SECTION 009113 - ADDENDA

PART 1 - Addendum #1

- A. Project Name: Maintenance Parking Lot Reconstruction Project
- B. Owner: Western Wyoming Community College
- C. Engineer: Brandt D. Lyman, PE, Western-EGI
- D. Engineer Project Number: 25-1015
- E. Date of Addendum: 04/15/2026

IMPROVEMENT PLAN NORTH
MAINTENANCE PARKING LOT
WWCC

TYPICAL HYDRANT INSTALLATION DETAIL

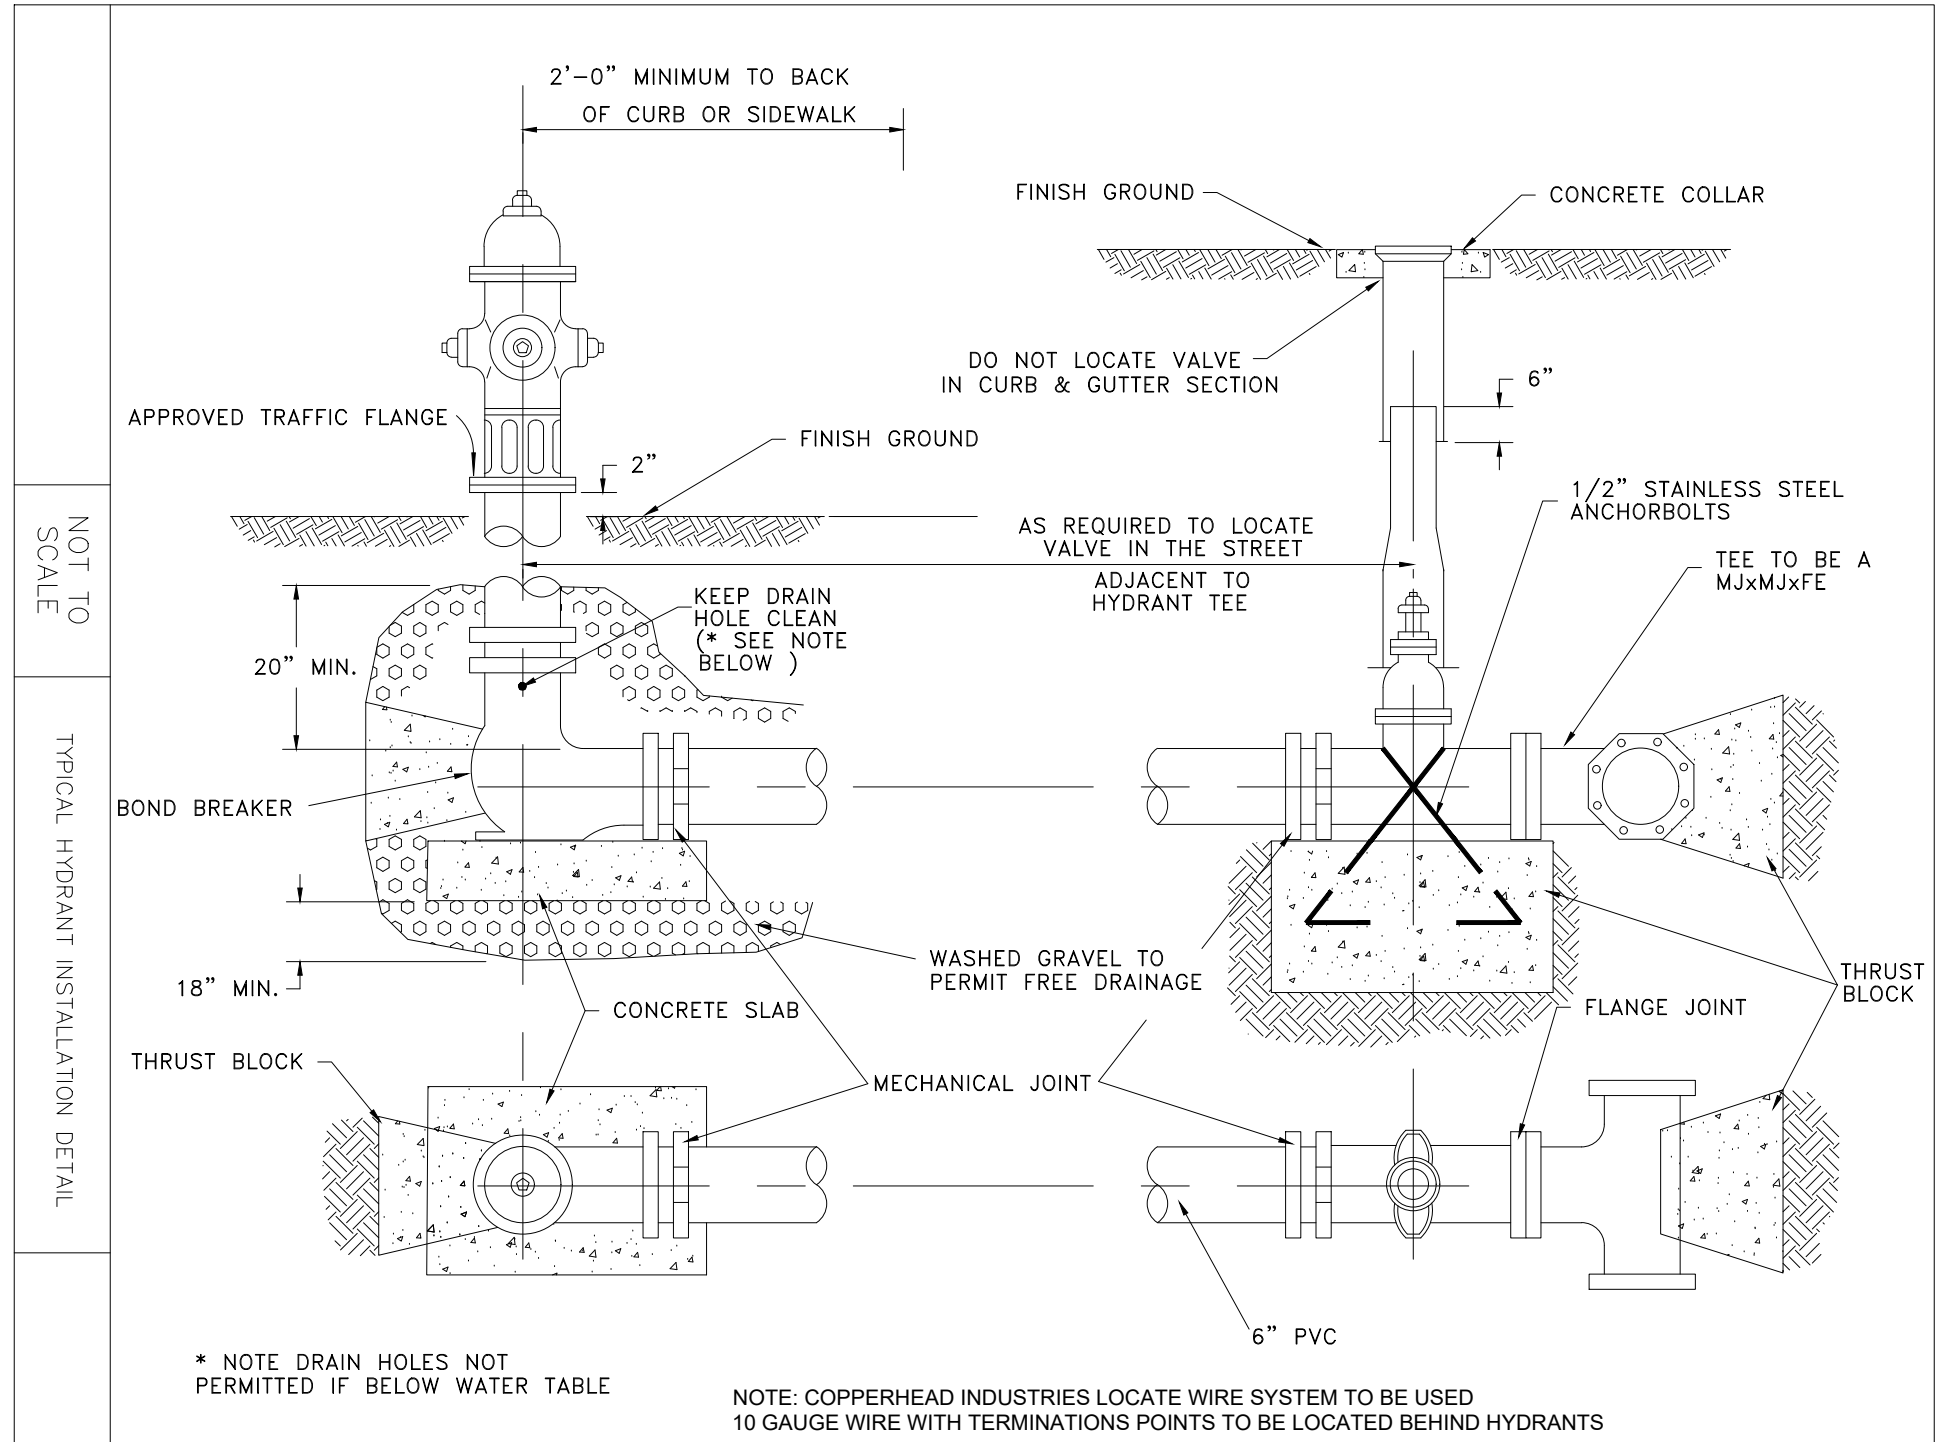
- A. This Addendum includes 4 attachments.
- B. This Addendum includes the following attached Documents and Specification Sections:
 - 1. Plans have been updated to include bollard detail and location and fire hydrant relocation and detail and curb cuts on new approach
